Technical Bulletin

Timing belt/kit installation on GM (Isuzu) 1.7D engines

This replaces Technical Bulletin N° 009.

Fig. 3

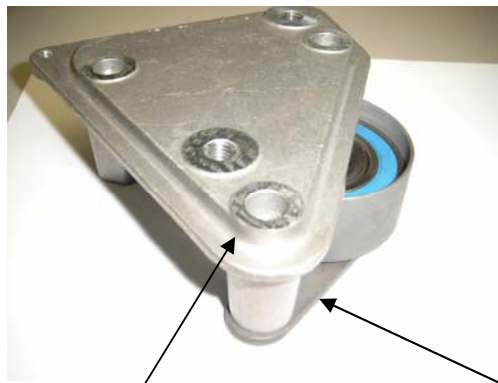
As the initial tensioner base plate was sitting under one of the legs of the engine support bracket (Fig. 3), K015563XS can only be used from engine nr 328704 on.

Fig. 5

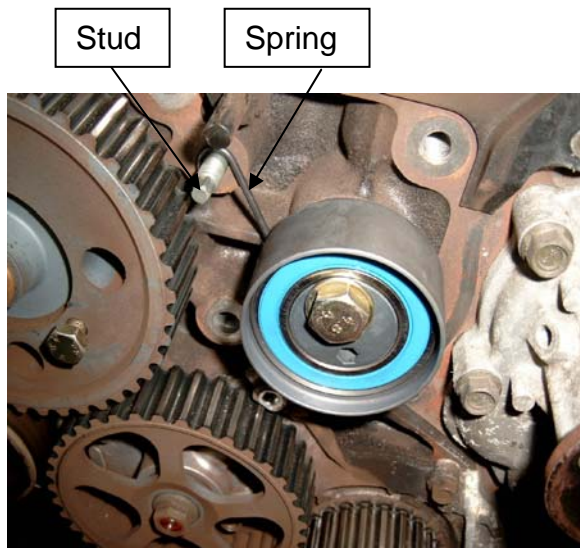
- 1) Remove old tensioner, spring, idler and belt
- 2) Install new idler and bolt
- 3) Insert and torque (18,6 Nm) stud at the right hand side of the injection pump pulley (Fig. 5)

Fig. 6

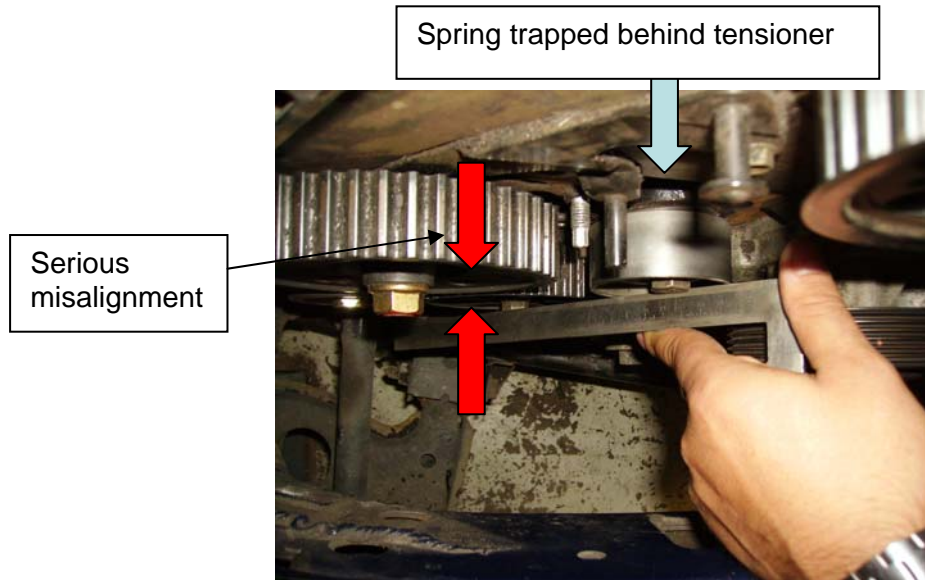
- 4) Install new coil spring tensioner (spring over stud, bolt hand tight); make sure tensioner is sitting perfectly against engine block. If not, the spring could end up between the tensioner and the engine block, creating a serious tensioner misalignment (see Fig. 6)

- 1) Remove old tensioner, spring, idler and belt
- 2) Install new idler and bolt
- 3) Install new coil spring tensioner (spring over stud, bolt hand tight); make sure tensioner is sitting perfectly against engine block. If not, the spring could end up between the tensioner and the engine block, creating a serious tensioner misalignment (see Fig. 6)

Fig. 7

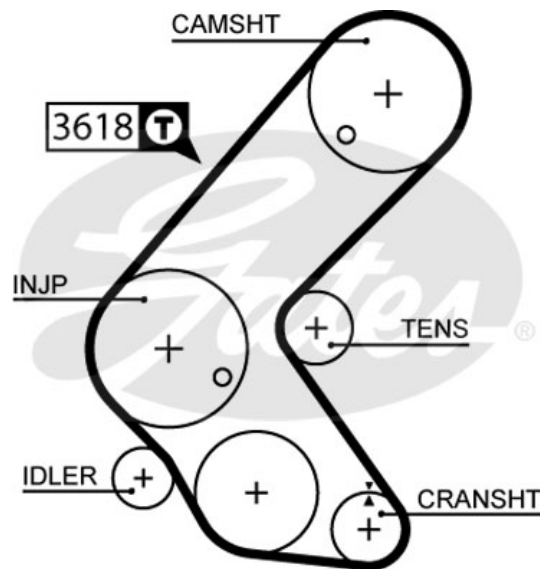
** After completing step 10 of the installation in procedure A), or step 9 in procedure B), it is highly recommended to check the tension in span

T, (see drive system layout below - Fig. 7) using the Gates Sonic Tension Tester STT-1.

To do this, enter the code 3618 in the STT-1 (ensure chip version 006 is installed) and measure in the normal way. If the tension is too high then the tensioner should be completely released and tensioning procedure repeated until the green light is obtained.

If the tension is too low then it will be necessary to assist the tensioner spring with the Allen key; until the green light is obtained.
